NOTICE OF DECISION

HISTORIC DESIGN REVIEW CASE NO.: HIS18-12

SUMMARY: A proposal to install new awnings and HVAC mechanical equipment on the Gray Building (c.1891).

PHASE 2
THE GRAY BUILDING
State Street & Liberty Street SE, Salem, Oregon 97301

B BUILDING SECTION - SIGHT LINES TO ROOFTOP EQUIPMENT
SCALE: NTS

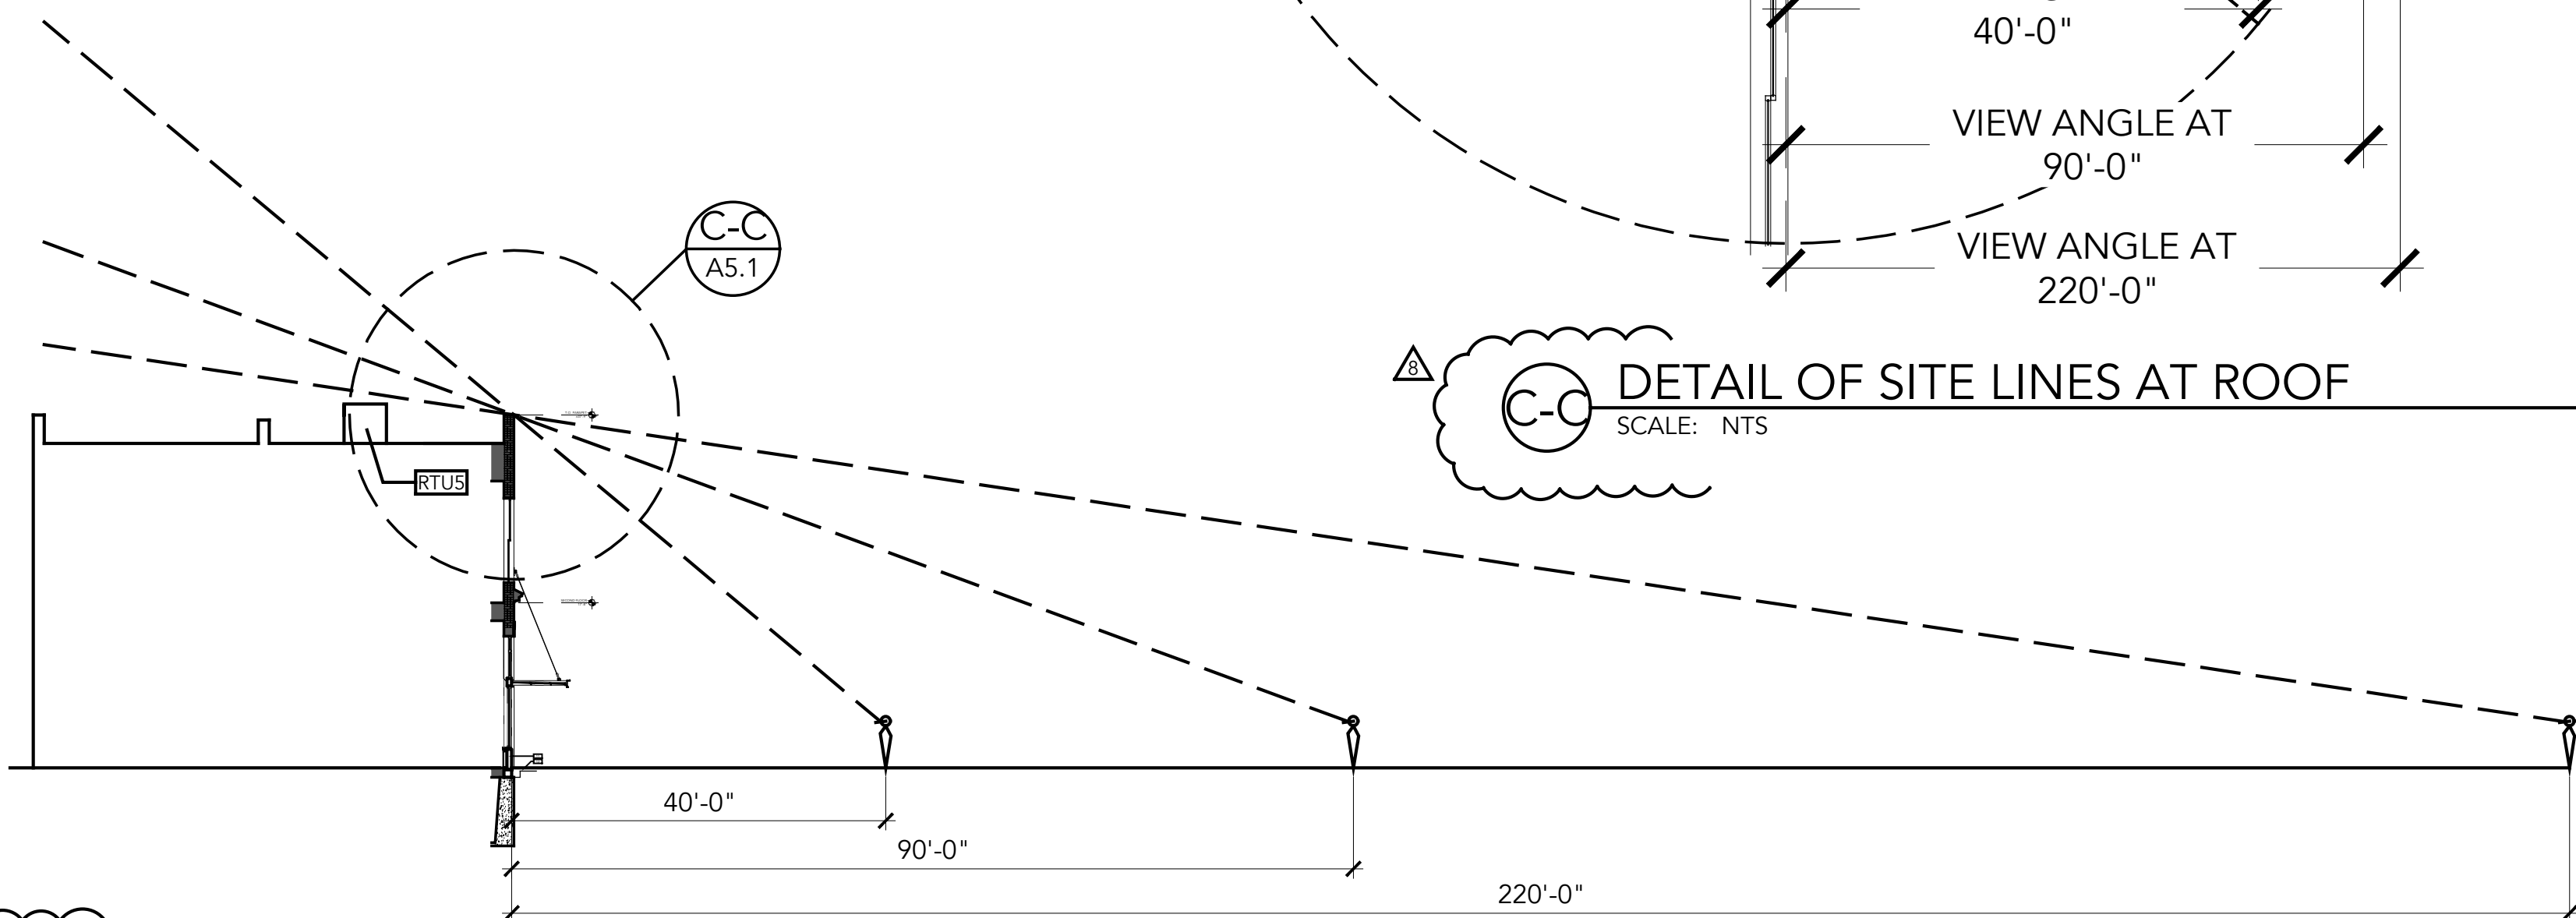
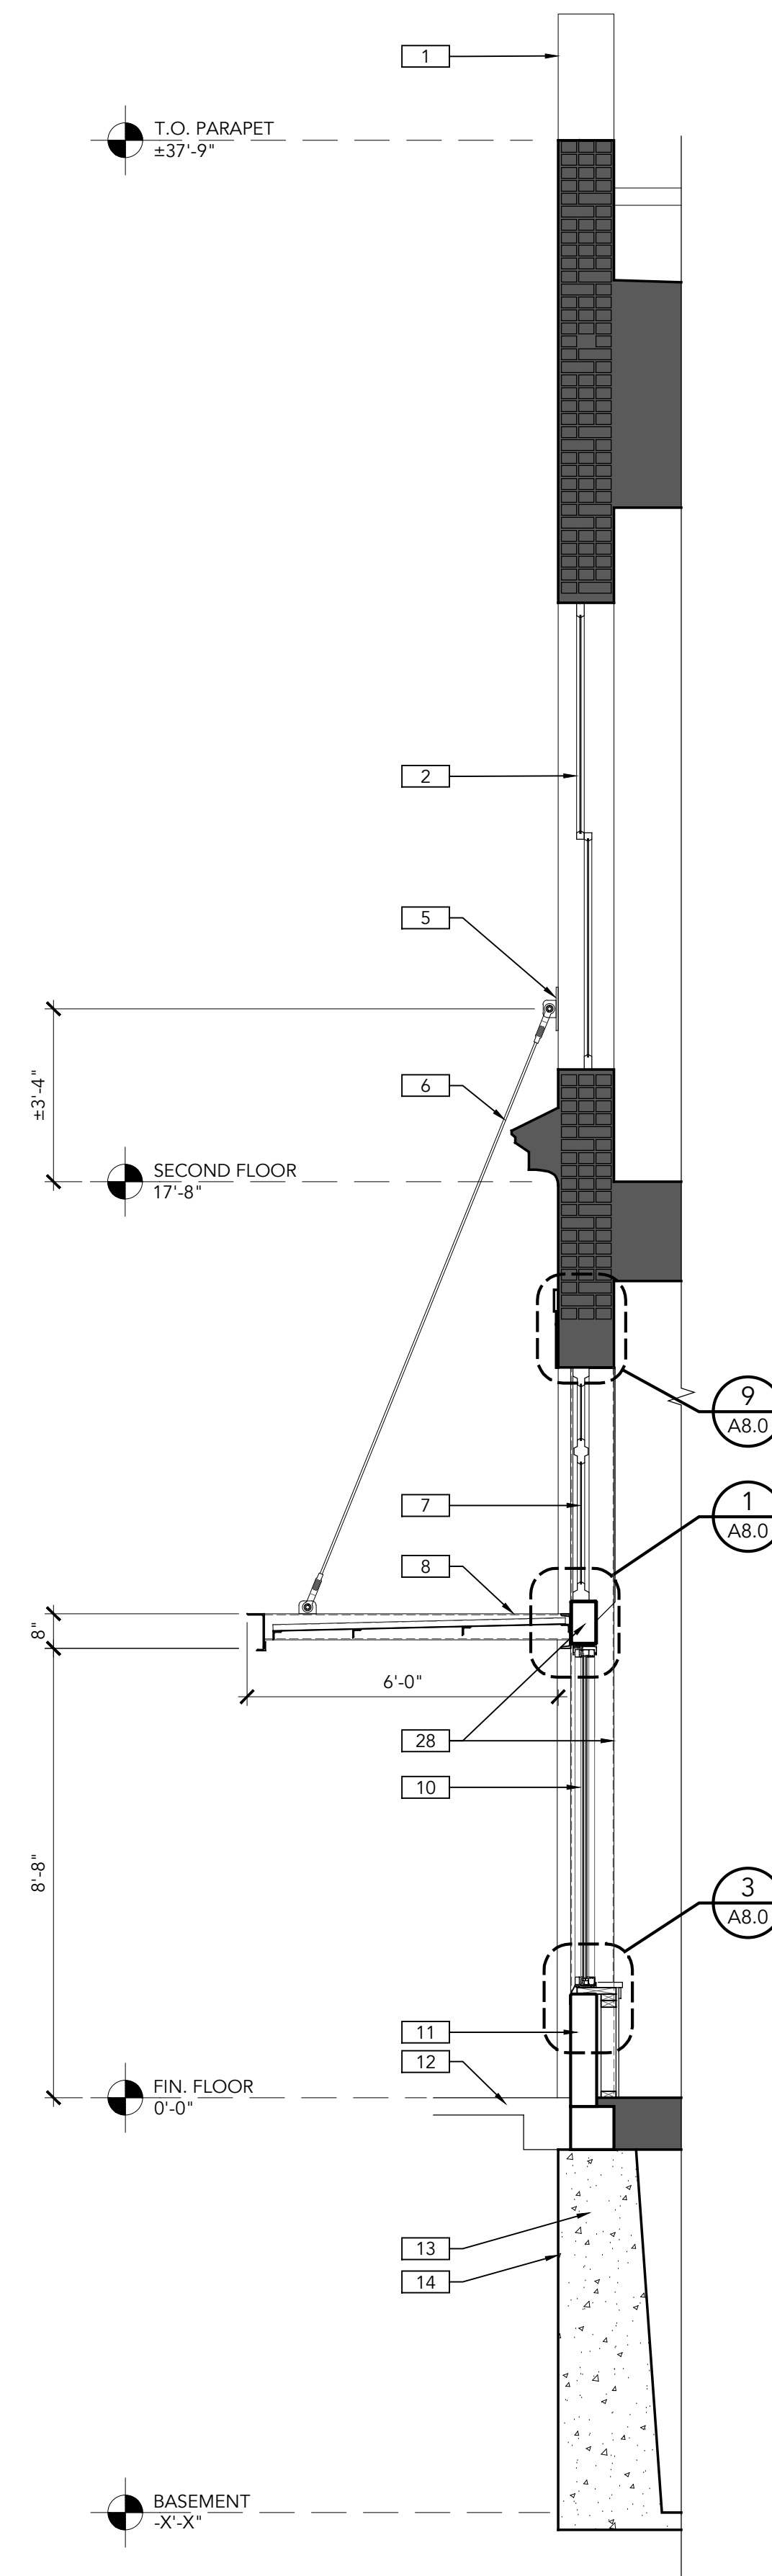
Thank you for opportunity to provide courtesy comments on the Gray Building in downtown Salem that is currently taking advantage of the Special Assessment Property Tax Program and the Federal Historic Tax Credit. All this work appears to meet the Standards and recommended for approval. While the new proposed HVAC is proposed for placement on the roof, they have been pushed back as far as possible from the parapet as to not be readily visible from the public right-of-way even though they appear visible (approximately 6 inches to a foot) in the two dimensional elevation drawings.
